SUBJECT: TECHNICAL REVIEW OF "TANK 18 AND 19 SPECIAL ANALYSIS
FOR THE PERFORMANCE ASSESSMENT FOR THE F-TANK FARM
AT THE SAVANNAH RIVER SITE", SRR-CWDA-2010-00124, REV. 0,
FEBRUARY 2012 (DOCKET NO. PROJ0734)

Technical Review of Tank 18 and 19 Special Analysis

Documents: *Tank 18 and 19 Special Analysis for the Performance Assessment for the F-Tank Farm at the Savannah River Site*, SRR-CWDA-2010-00124, Rev. 0, February 2012

Figure 1 Barriers to Timing of Peak Dose for Type IV Tanks in DOE's Reference Case

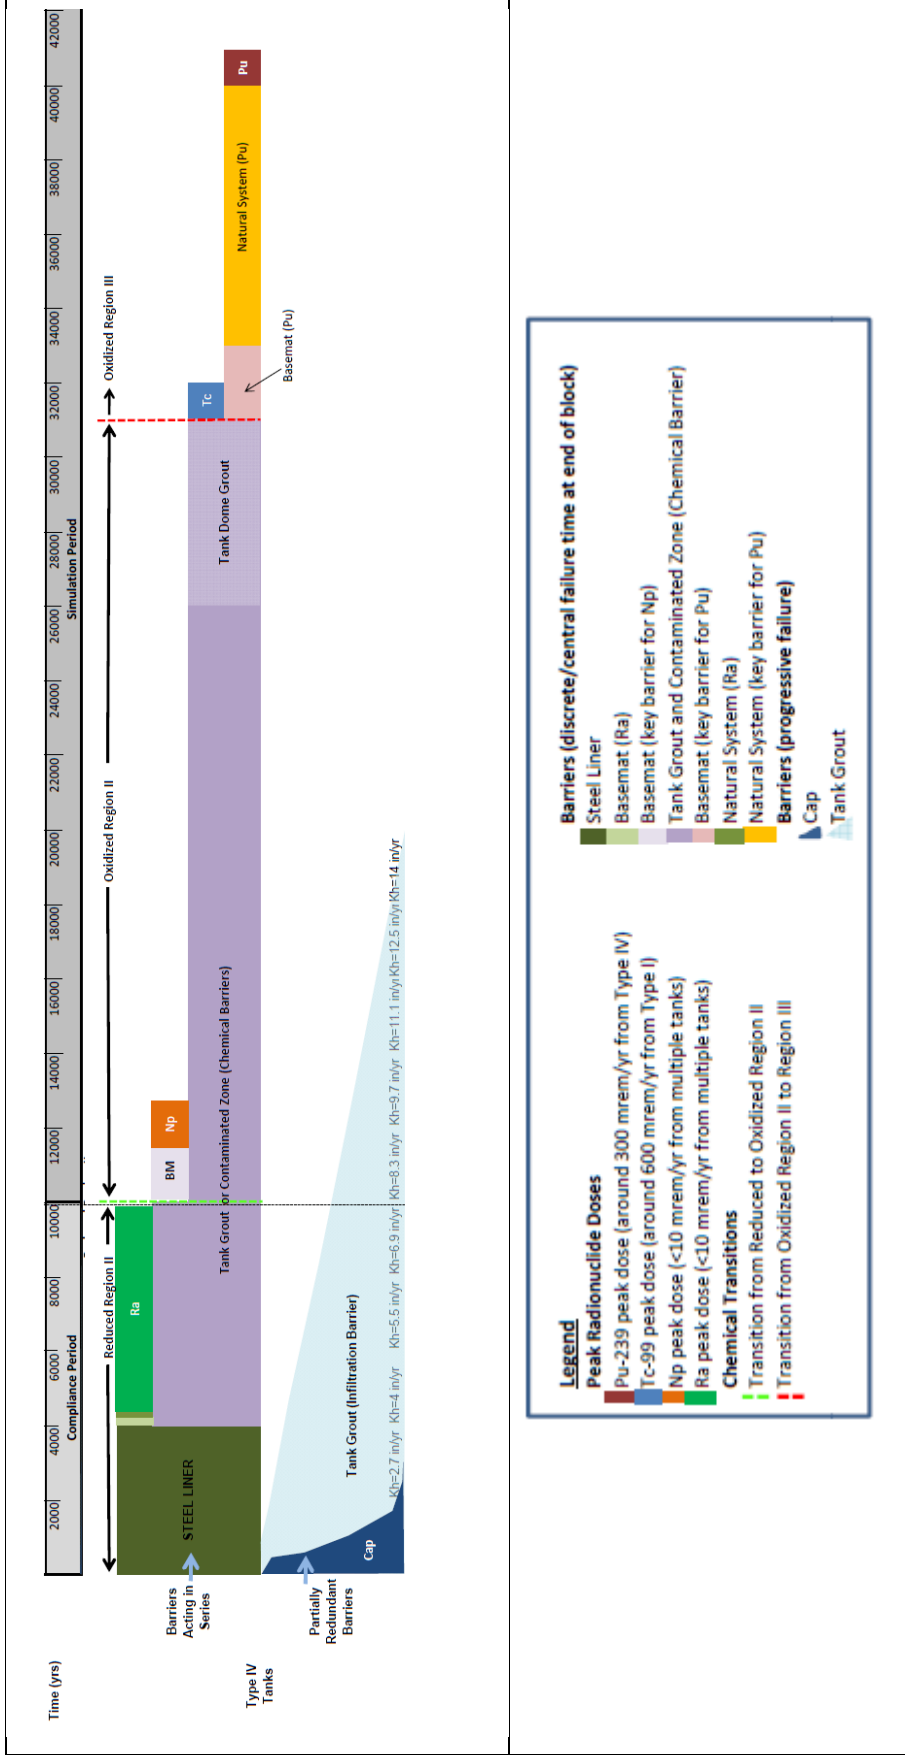
Figure 1 shows that the chemical barrier afforded by the tank grout or contaminated zone (shown in purple) is the single-most important barrier affecting the timing of peak Pu-239 dose in DOE's reference case. The green, vertical line in Figure 1 shows the first chemical transition modeled in DOE's PA that delineates the transition from reduced to oxidized conditions. As discussed above, if the E_h of the system is above around +0.45 V in the oxidized (Region II) chemical state, DOE's updated solubility modeling shows that the release of Pu-239 from Tank 18 could be risk-significant much earlier in time at around 10,000 years. Thus, the updated solubility modeling shows that a factor of approximately 3 earlier time-to-failure of the most important barrier to timing of peak dose, the tank grout/contaminated zone chemical barrier, could occur making a peak dose within 10,000 years much more plausible.

Another source of uncertainty in the timing of peak dose related to chemical transition times was addressed by DOE in a Request for Additional Information (RAI) response but was not considered in the Tanks 18 and 19 special analysis. In FTF RAI response (DOE, 2011), DOE performed a "Case G" analysis to study a potential conceptual model referred to as Condition 2 in DOE's PA (SRS-REG-2007-00002, Rev. 1). In Condition 2, a fast flow path exists through the tank grout prior to significant (bulk) grout degradation. Therefore, flow through the system is dominated by fractures or cracks that might form in the system over time (e.g., shrinkage gaps, or cracks that might develop due to thermal or mechanical stresses imposed on the system during curing, or due to corrosion of steel components) and waste release is dominated by water that, after a short period of time, is not assumed to be chemically conditioned via prolonged interactions with the reducing grout. Because the Case G scenario defeats the primary barrier prolonging the peak dose in DOE's FTF PA (i.e., the purple, chemical barrier shown in Figure 1), the peak dose occurs within the 10,000 year performance period¹ at doses

DOE's updated solubility modeling shows that the chemical barrier for Pu-239 may be much less effective at around 10,000 years or upon transition to oxidized conditions delineated by the vertical, green line in Figure 1 (versus 30,000 years delineated by the vertical red line in Figure

1). DOE did not evaluate alternative conceptual models (e.g., flow through cracks in the tank grout) in its special analysis that may also lead to earlier chemical transitions times (a shift in the vertical green line to earlier times). Therefore, it will be important for DOE to provide additional support for its reference case PA model or to rule out alternative configurations that may lead to unacceptable results.
